NO.	DATE	BY	CHKD	ENGR	PROJ	DESCRIPTION
B	5-22-96	MCS	DM	BP	DM	BID ADDENDUM #2
A	4-19-96	MCS	DDM	BP	TDM	FINAL DESIGN REVIEW & BID

LASER INTERFEROMETER
 GRAVITATIONAL-WAVE OBSERVATORY
 SITE NO. 1 - HANFORD, WASHINGTON

TITLE: STRUCTURAL MID STATION "B" & END STATION "B" FOUNDATION PLANS

SHEET NUMBER: WA-S-208

ARM I (SOUTHWEST ARM)
 MID STATION "B" FOUNDATION PLAN
 $\frac{1}{8}'' = 1'-0''$
 DATUM POINT EL 100'-0" = EL 532.22'

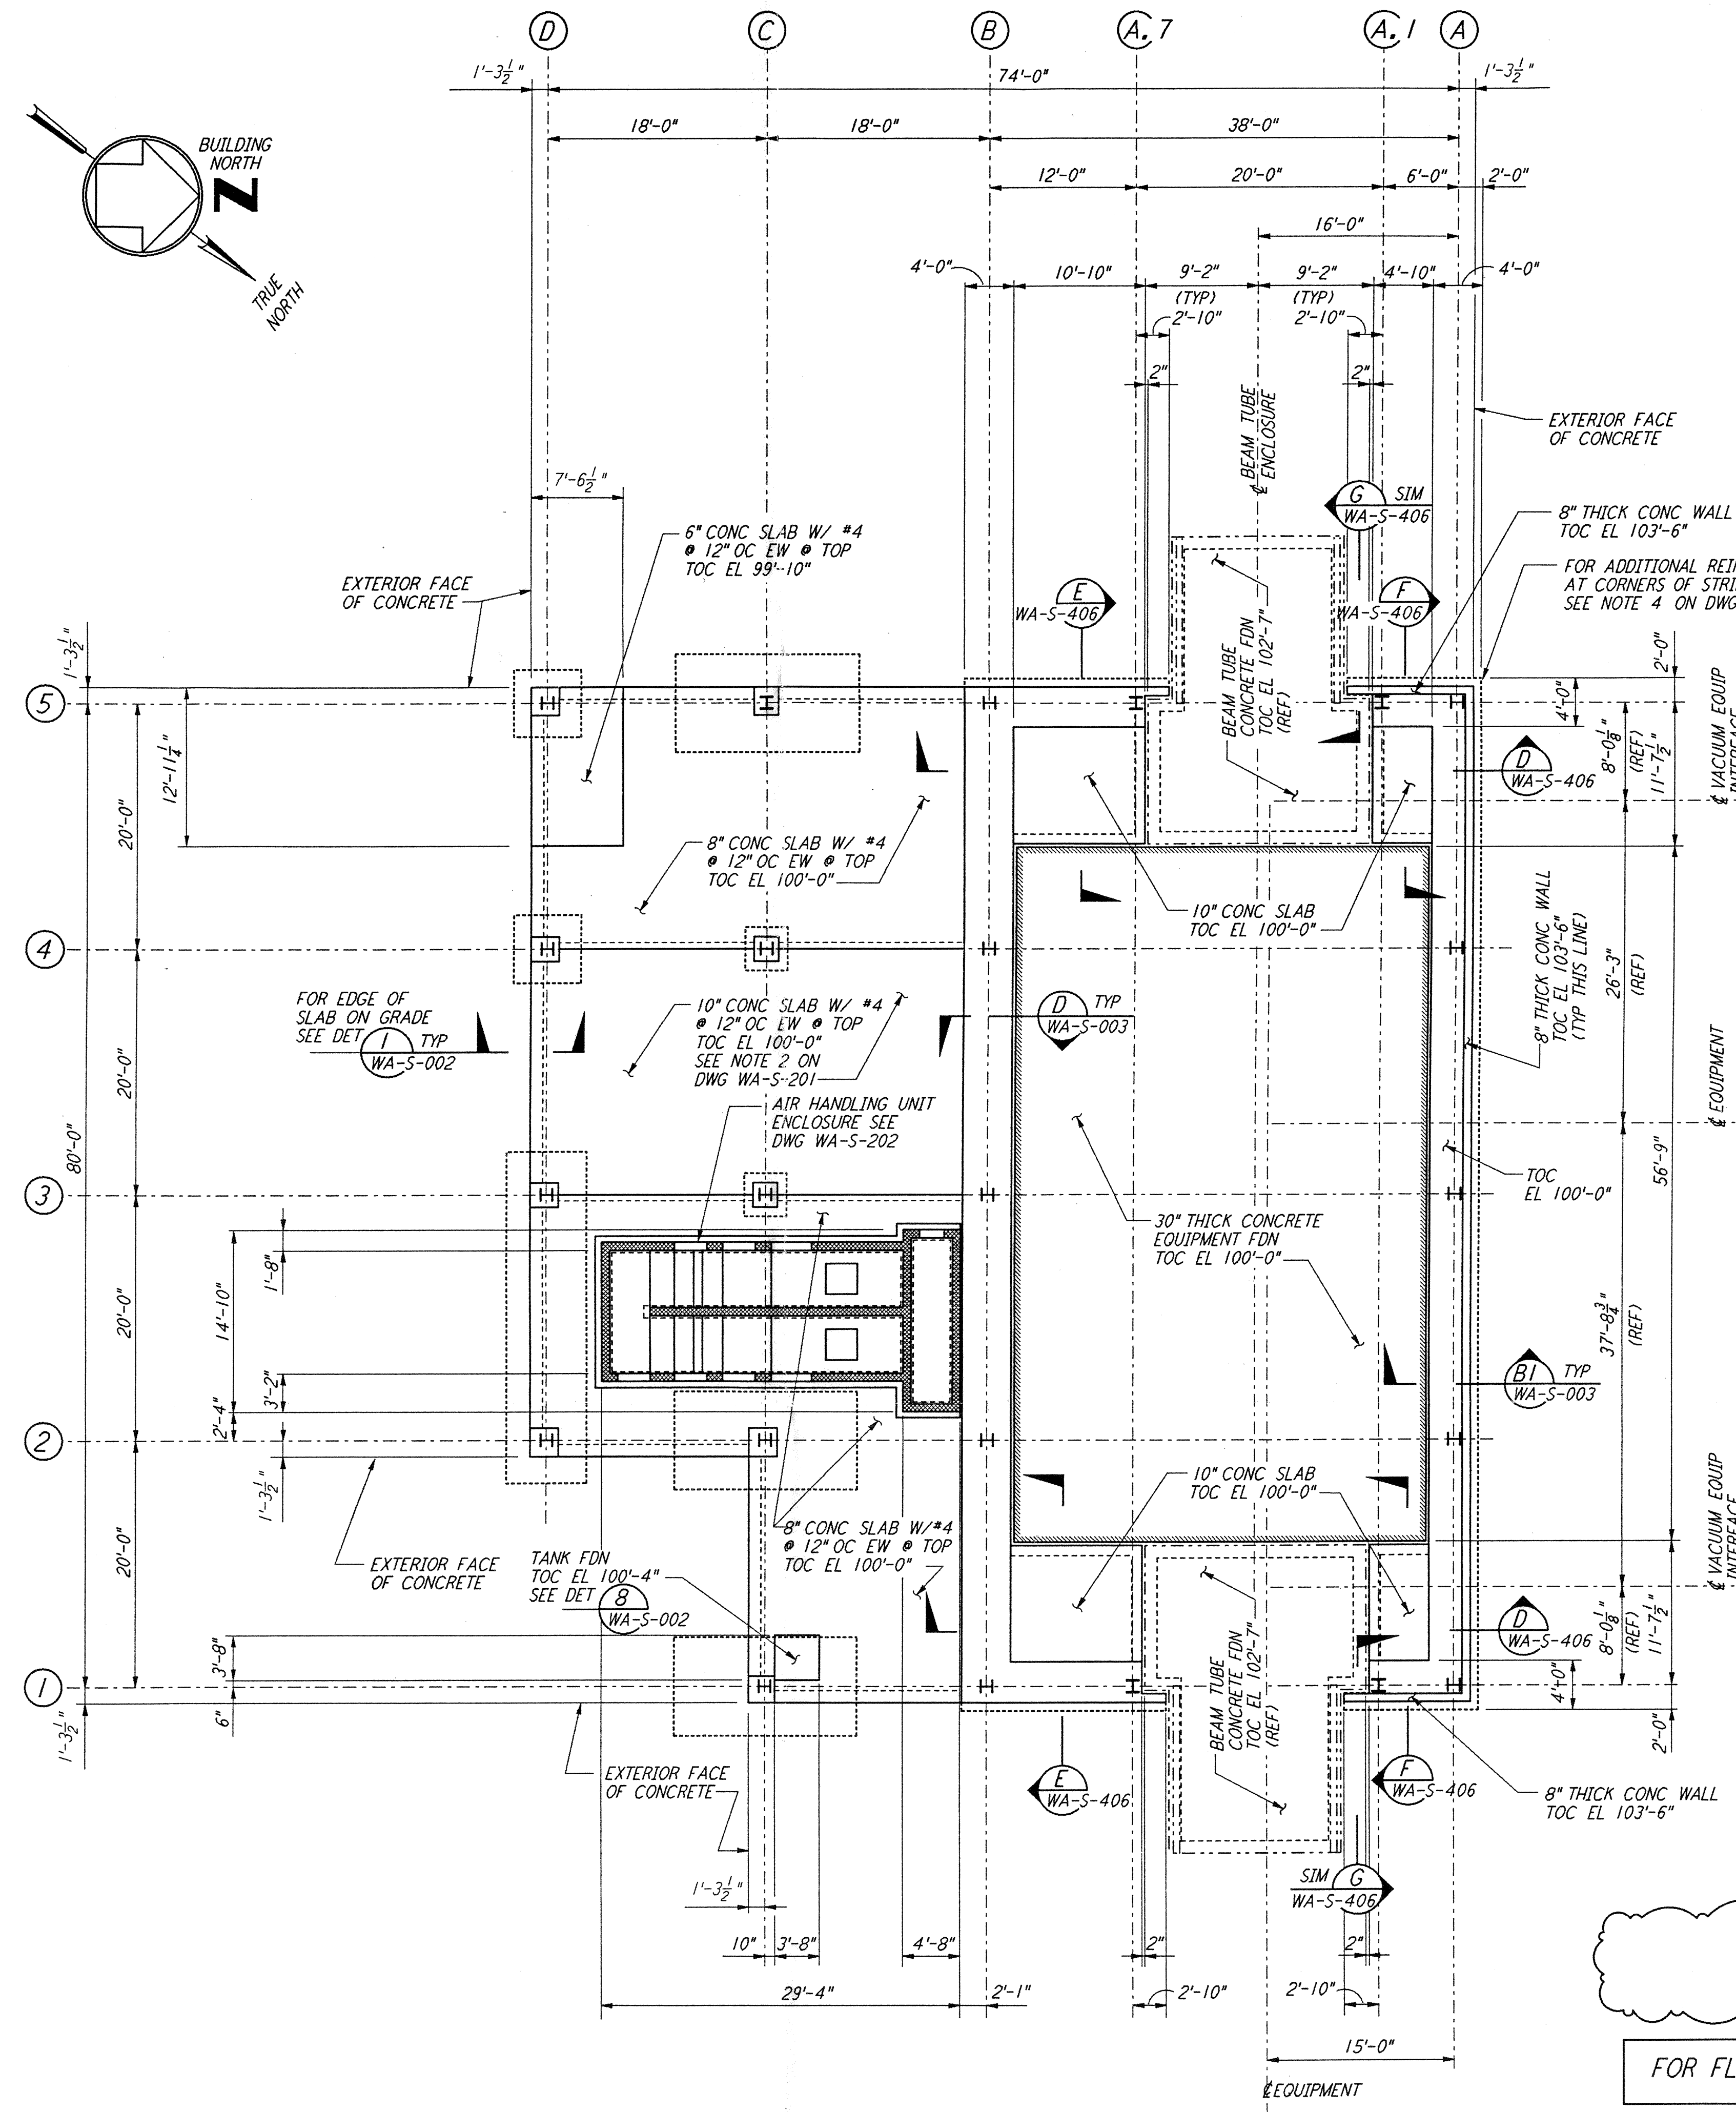
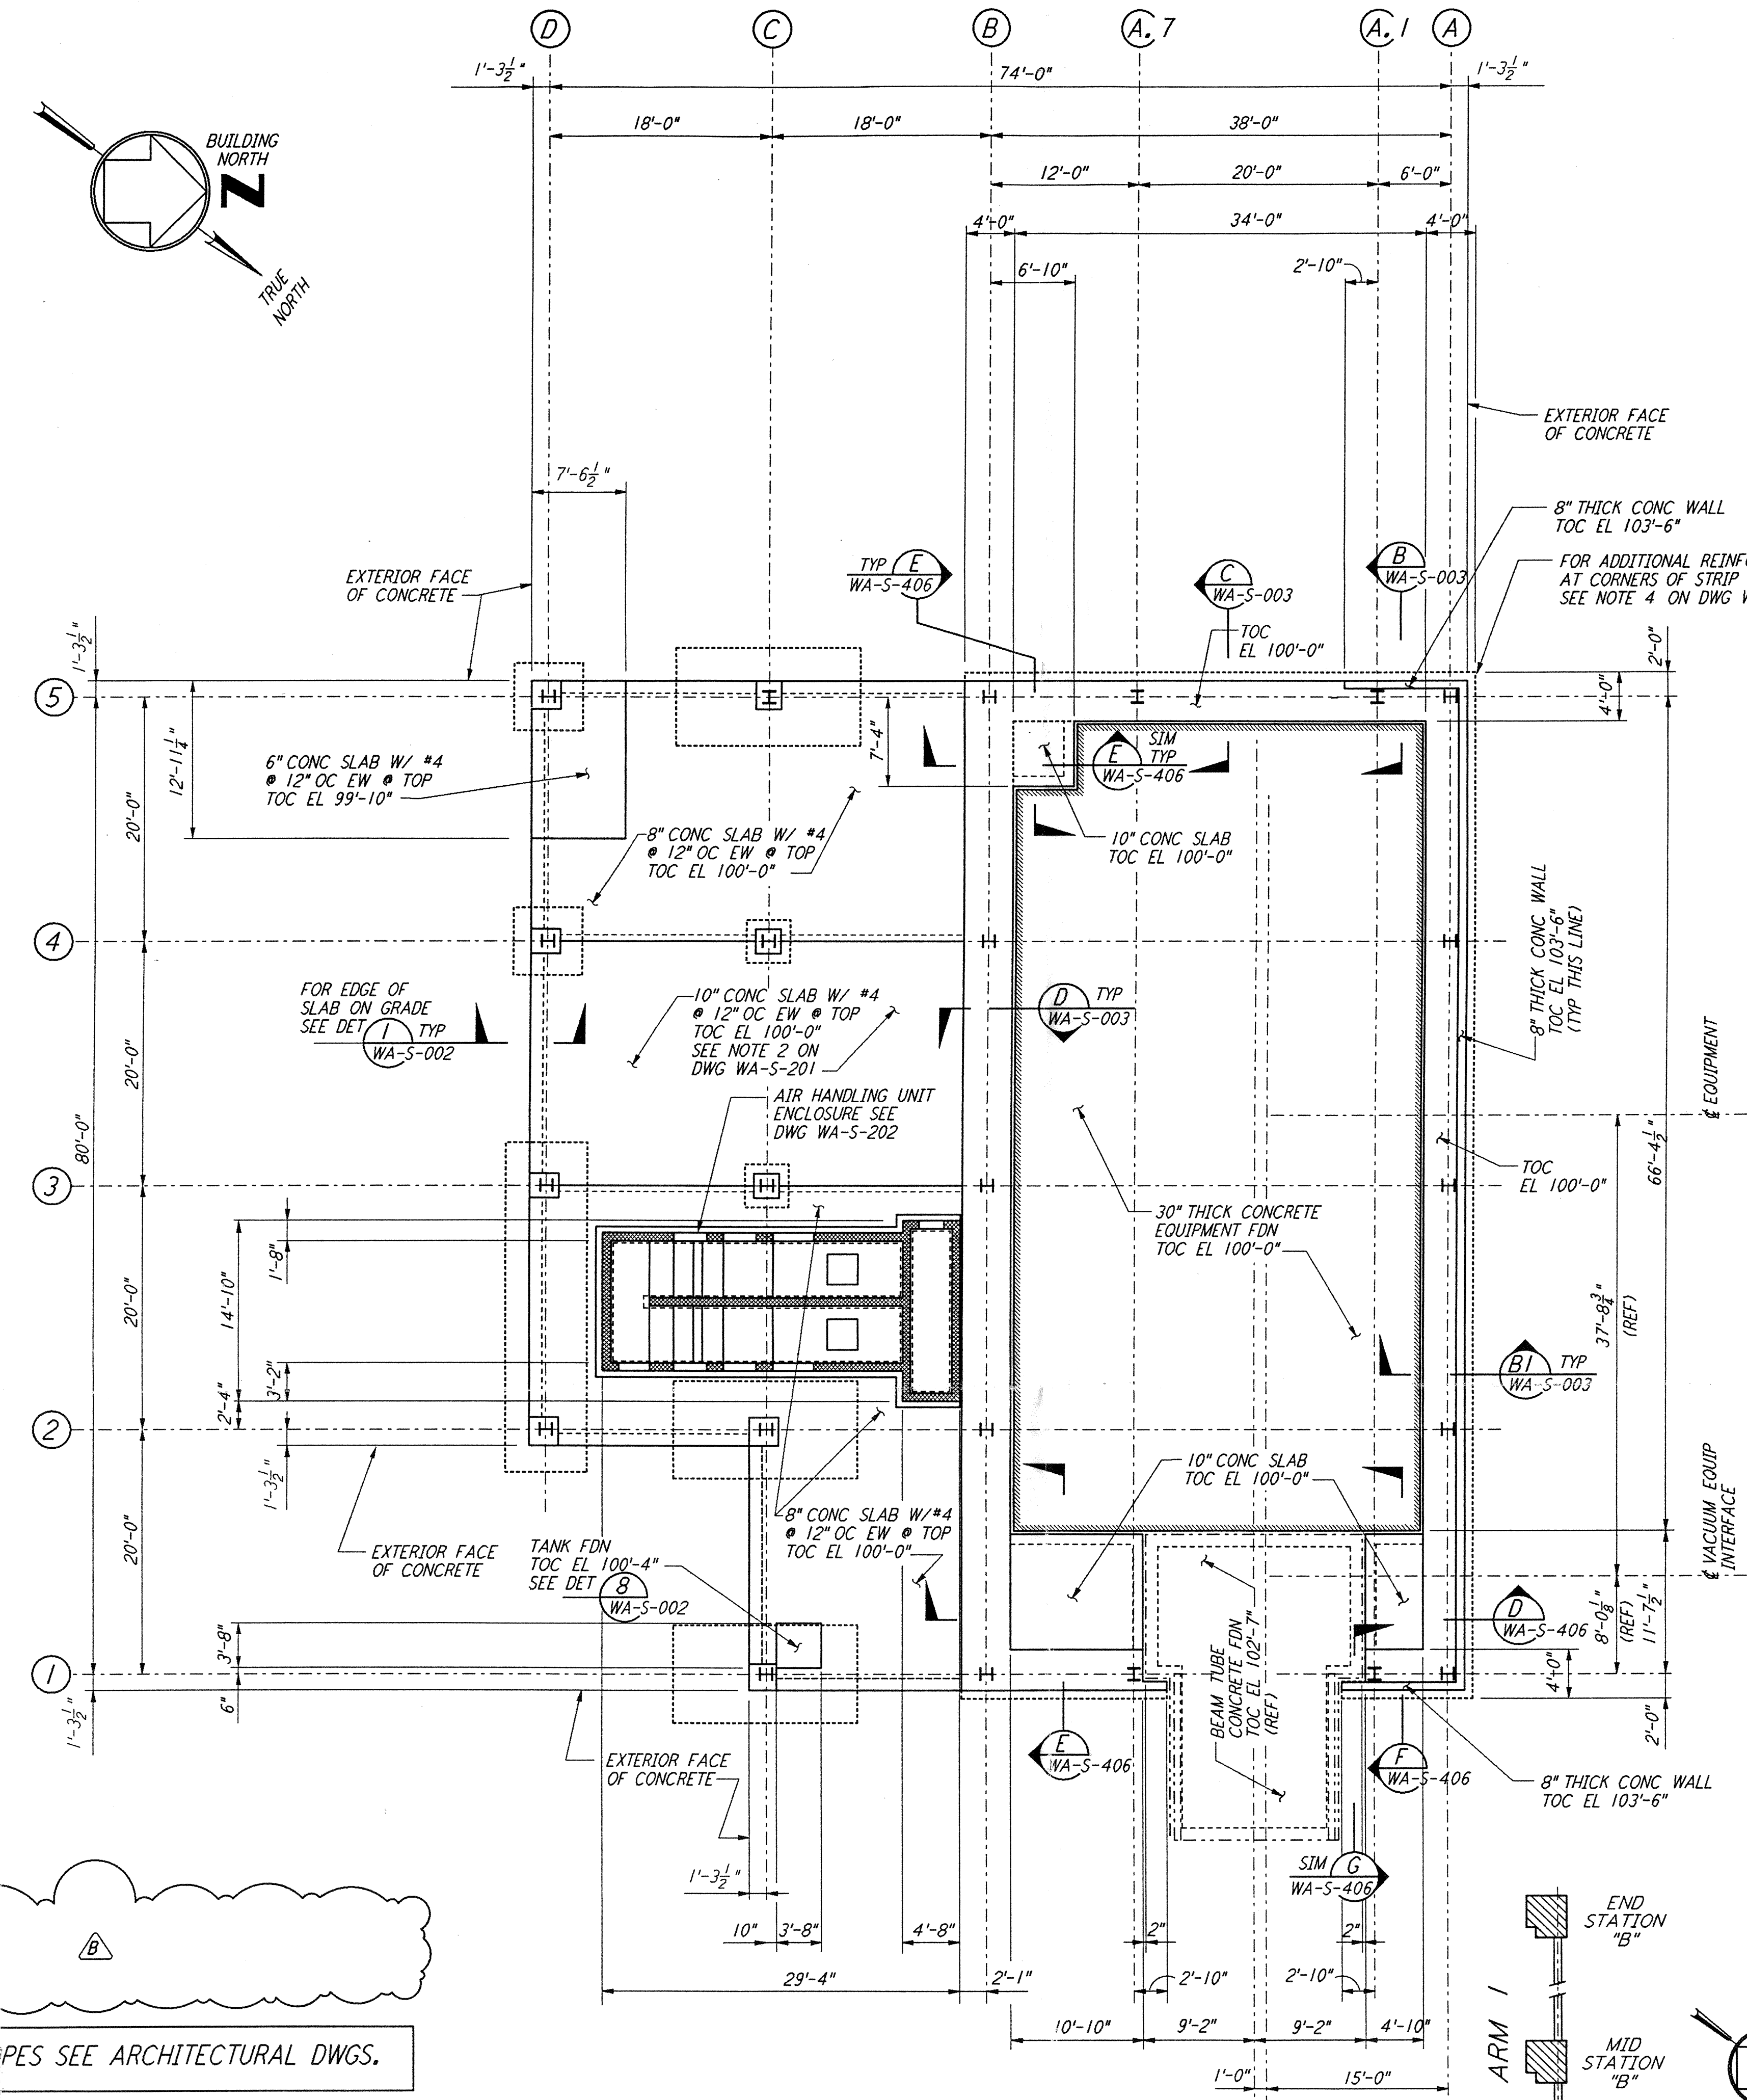
- EQUIPMENT FOUNDATION NOTES:**
1. CONCRETE FOR EQUIPMENT FOUNDATION SHALL BE PLACED IN MULTIPLE LIFTS OF ONE (1) FOOT OR MORE WITH A FINAL LIFT OF SIX (6) INCHES.
 2. FIBERMESH FIBERS (MANUFACTURED BY FIBERMESH, CHATTANOOGA, TENNESSEE OR EQUAL) SHALL BE MIXED WITH CONCRETE FOR THE FINAL LIFT OF SIX (6) INCHES FOR THE EQUIPMENT FOUNDATION.
 3. CONCRETE SURFACE SHALL BE CLEANED, RAKED AND ROUGHENED TO DEVELOPE BOND BETWEEN CONCRETE LAYERS.
 4. TOP REINFORCEMENT OF EQUIPMENT FOUNDATION SHALL HAVE $\frac{1}{4}''$ CLEAR COVER. CONTRACTOR SHALL TAKE ALL THE NECESSARY PRECAUTIONS TO MAINTAIN UNIFORM COVER.
 5. CONTRACTOR SHALL HAVE SPARE PUMPS TO ENSURE UNINTERRUPTED PLACEMENT OF CONCRETE.
 6. EQUIPMENT FOUNDATION SHALL BE CURED BY MEMBRANE CURING METHOD AS PER SPECIFICATIONS.
 7. THE WORK MARKED BY HAND ON THIS DRAWING IN REVISION "A" DATED 4-19-96 HAS BEEN RESTORED TO THIS CONTRACT.
